Dwire Earthmoving

Designed by: Elysa Engle
Date: 1.24.2020
Revised:
Scale: 1" = 10'

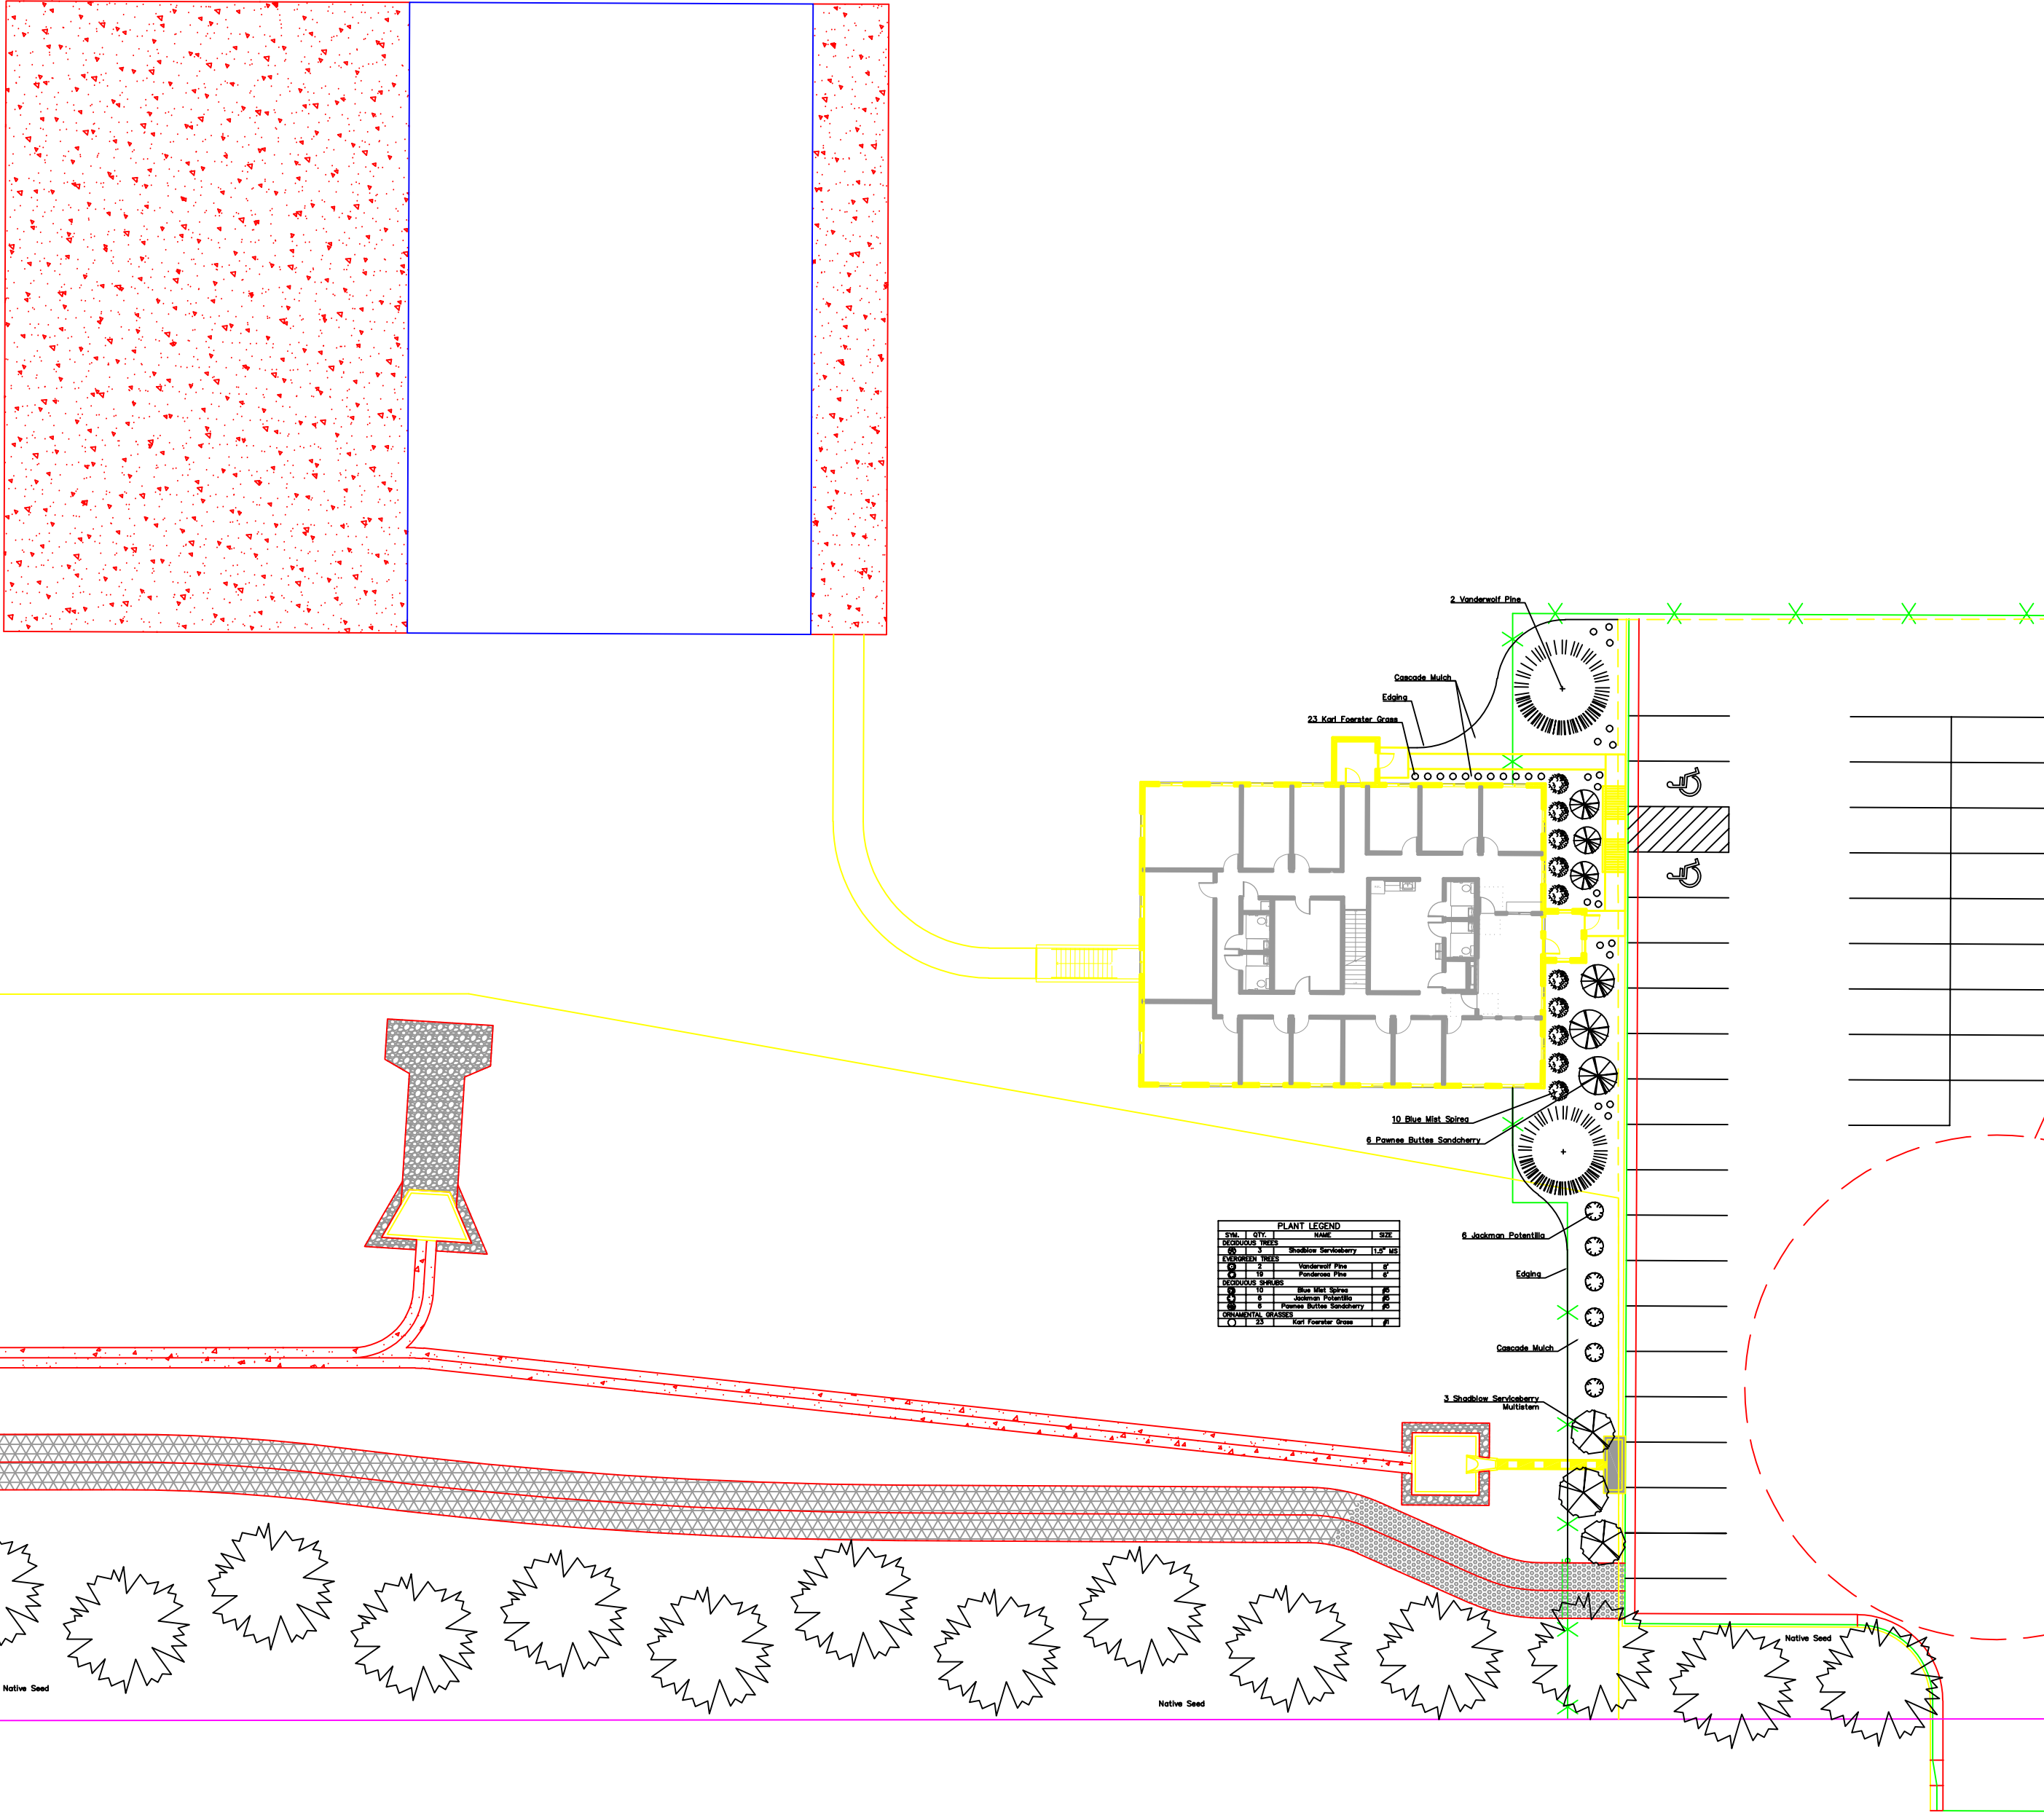
No north arrow, property lines still need to be labeled.No parking lot landscaping No seeding indicated No Alternative Landscape Design requested. Unless requested in the letter of intent, all standard in Chapter 6 of the LDC are required to be met. please provide a tree count. Consider the next round of comments to be a first round of comments. Please refer to chapter 6 of the LDC to put together a landscape plan.
